## HISTORIC PRESERVATION COMMISSION

SUBJECT: Historic Area Work Permit #488048 – addition and alterations to house

<b>Address:</b>	5815 Cedar Parkway, Chevy Chase	<b>Meeting Date:</b>	7/9/08
<b>Resource:</b>	Contributing Resource Chevy Chase Village Historic District	<b>Report Date:</b>	7/2/08
<b>Applicant:</b>	Richard and Amy Zantzing (Chris Snowber, Architect)	<b>Public Notice:</b>	6/25/08
<b>Review:</b>	Preliminary Consultation	<b>Tax Credit:</b>	None
<b>Case Number:</b>	35/13-080	<b>Staff:</b>	Anne Fothergill
<b>PROPOSAL:</b>	Construction of additions, dormers, front walkway and other alterations to house

**From:** Chris Snowber [chris@hamiltonsnowber.com]  
**Sent:** Tuesday, June 17, 2008 1:23 PM  
**To:** Fothergill, Anne  
**Subject:** 5815 Cedar Parkway  
**Attachments:** HAWP-WebRevised.pdf; ATT73842.htm

Proposed (Front) Elevation

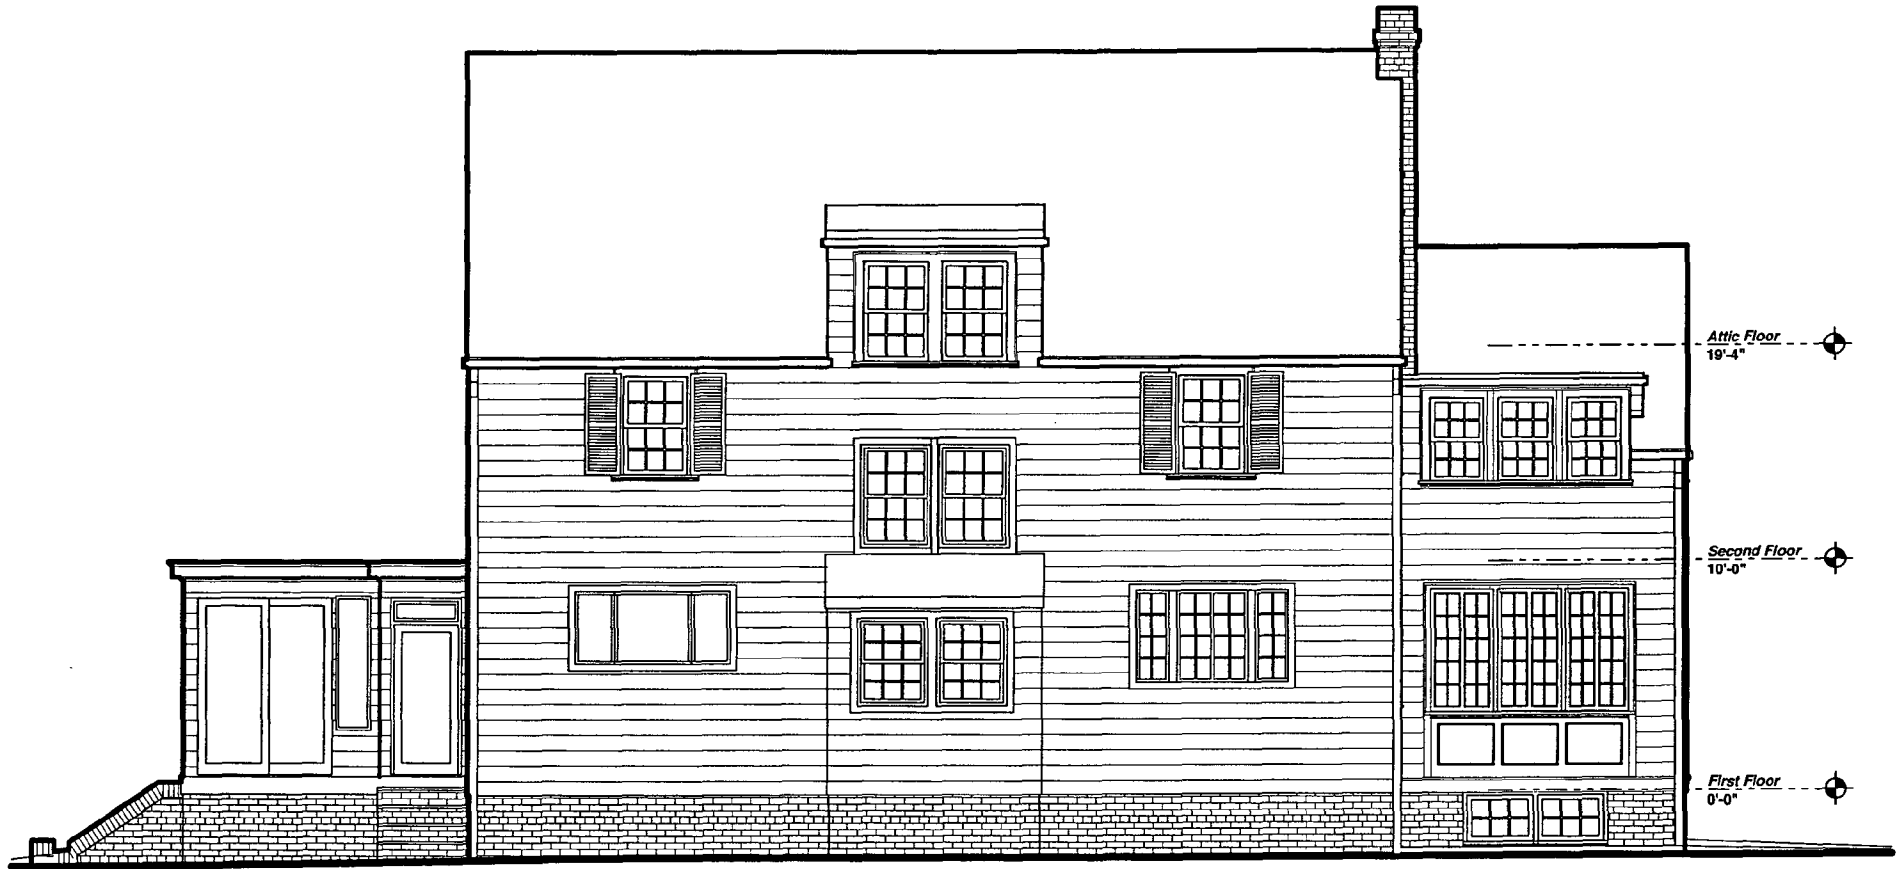
Face of addition set 1'-0" back from main mass.  
Casement windows with panels used at First Floor.

Proposed East Elevation

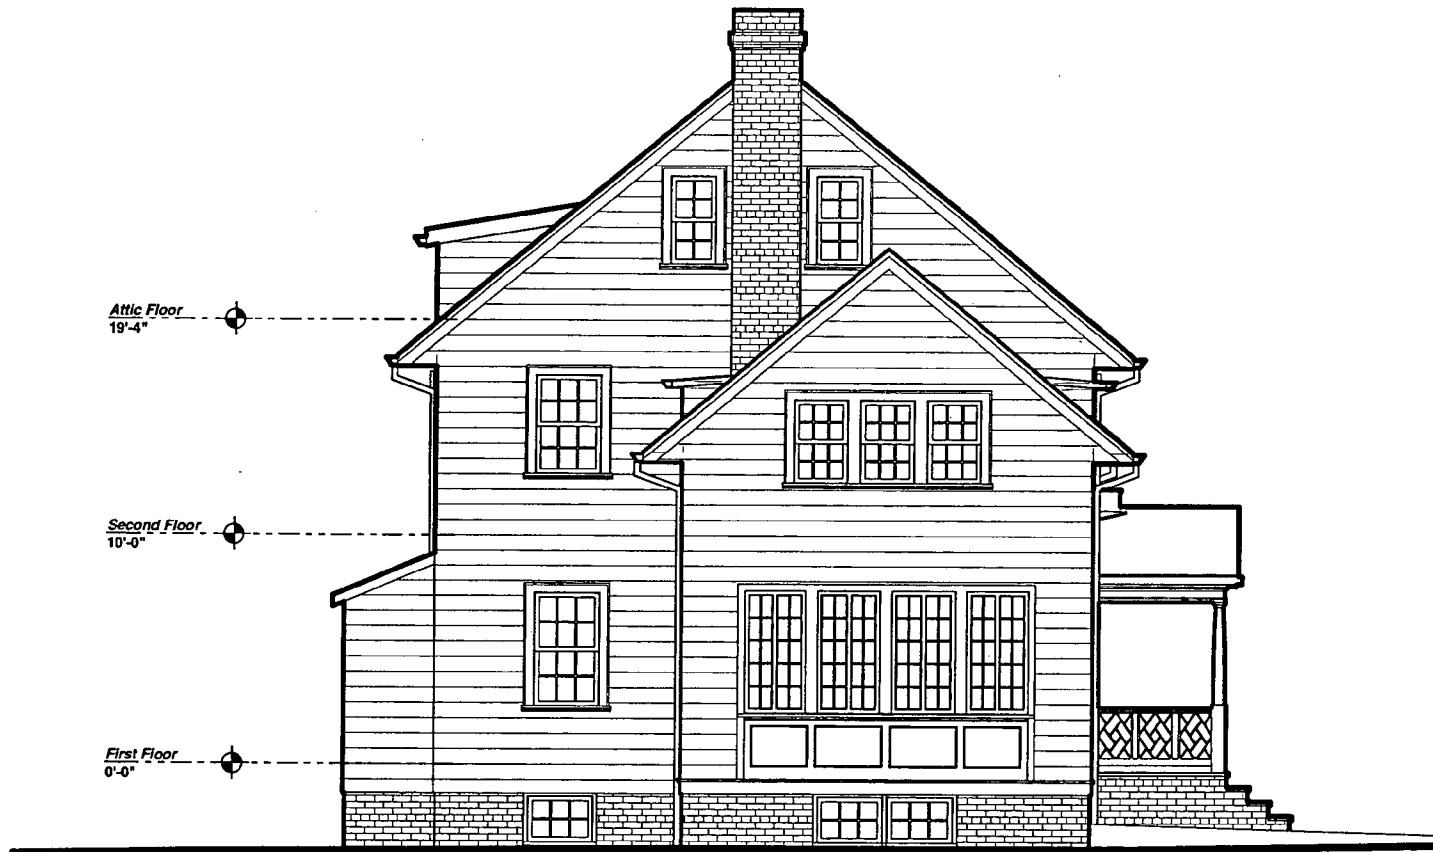
At BR porch, casement windows with panels used at First Floor.  
At Kitchen, casement windows similar to other wings used, with panels below.  
At Master Bath, connect the dormer to the main block of the house, as is done on the existing North extension.  
Columns are now square, rather than round.  
At LR windows under porch, use a 4-lite wide window, with shutters, to match the front of the house.

First Floor Plan

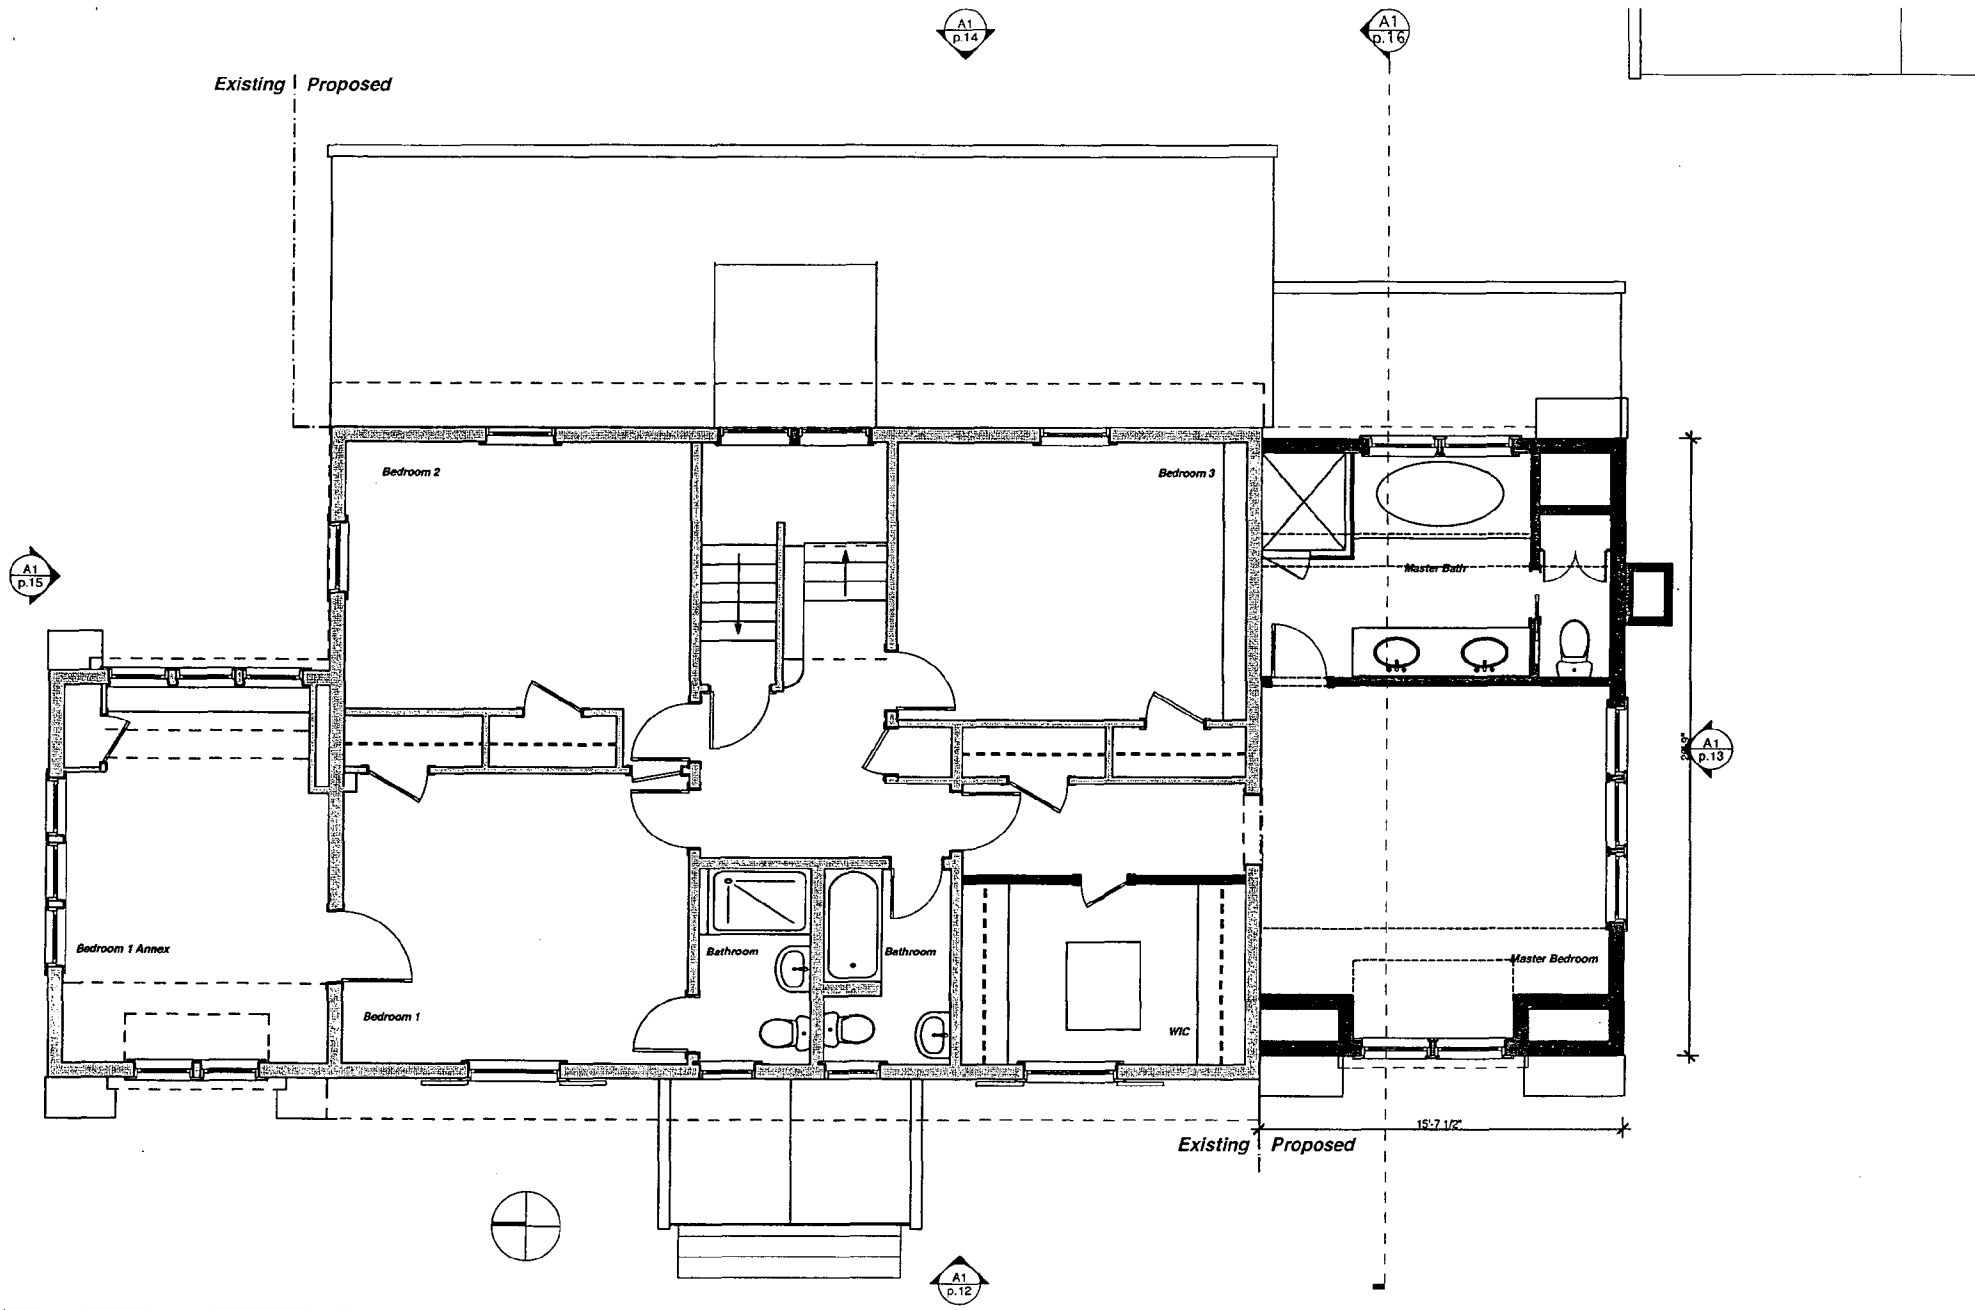
As per the suggestion of the HPC, we have pushed the face of the building back 1'-0" from our earlier submission. This makes the mass of the addition more secondary to the main mass.

We have also re-organized the plan, so that the kitchen is now at the rear. This means that the windows at the front (West) elevation can match in height the casement windows on the existing north wing.

The rear addition, including the porch and kitchen, has gotten approximately 8" deeper.

Right side elevation - preliminary consultation

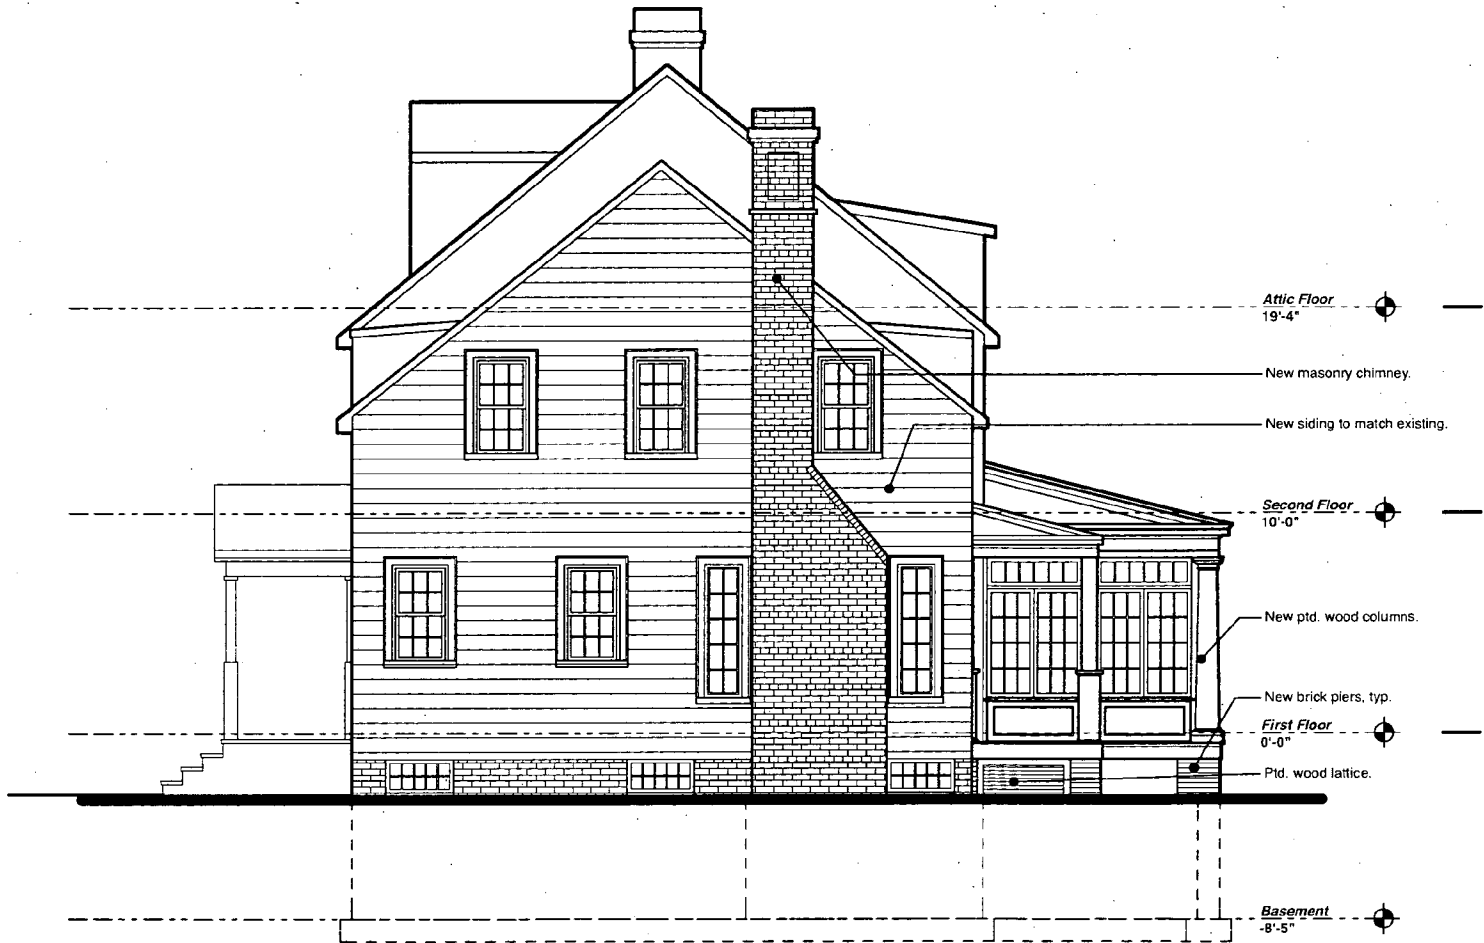
Staff noted that the HPC "generally does not support side additions", but "if a new two-story addition is supported by the Commission," then staff would recommend that the addition be set back.  
The LAP concurs with that recommendation. Our Guidelines do permit major additions on the sides of houses under certain limited circumstances, and the LAP's view is that the circumstances here do warrant permitting a major side addition if it is set back and not flush with the front plane of the house. In this case (as opposed to the next case) the prior addition is to be completely removed and the location of the design aspect questioned by staff is on the front of the house. Therefore we fully support the staff recommendation.

Zantinger Residence First Floor Construction Plan 1/8" = 1'-0" 10/2/07

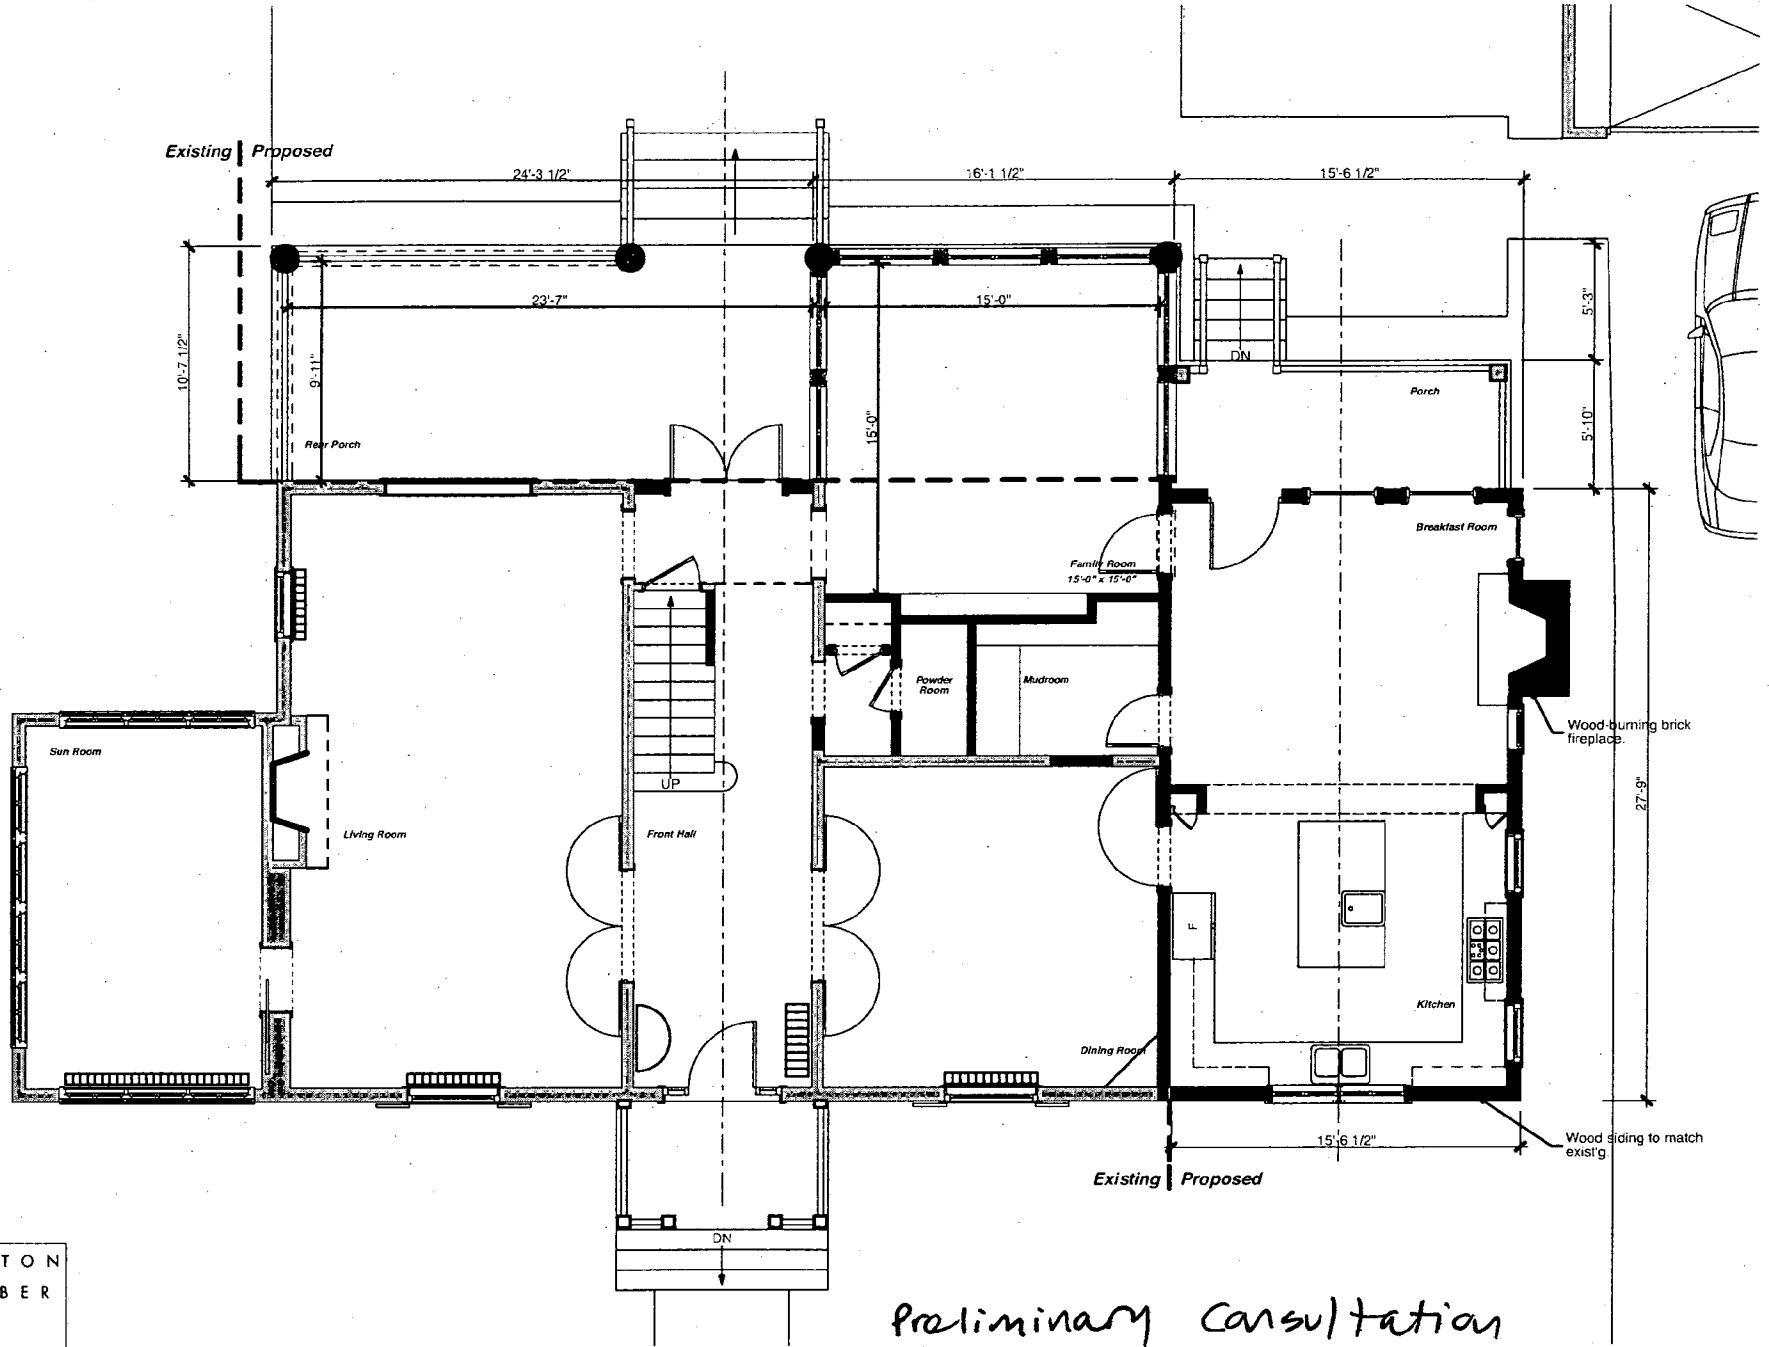
MR. SNOWBER: I'm looking right now at the first floor plan on 17. Yes, 17. We also like the idea of preserving, of having this one-story porch that stretches across the whole back, appearing dominant and being connected to the main mass. As this secondary porch and the addition push further back, those two start to blend together in an odd way. I like the, I like the distinction between them on the rear elevation right now.

MS. ALDERSON: We're looking at the detail. If you were to move it back even just a few feet, that would still have the porch recessed in relation to the other.
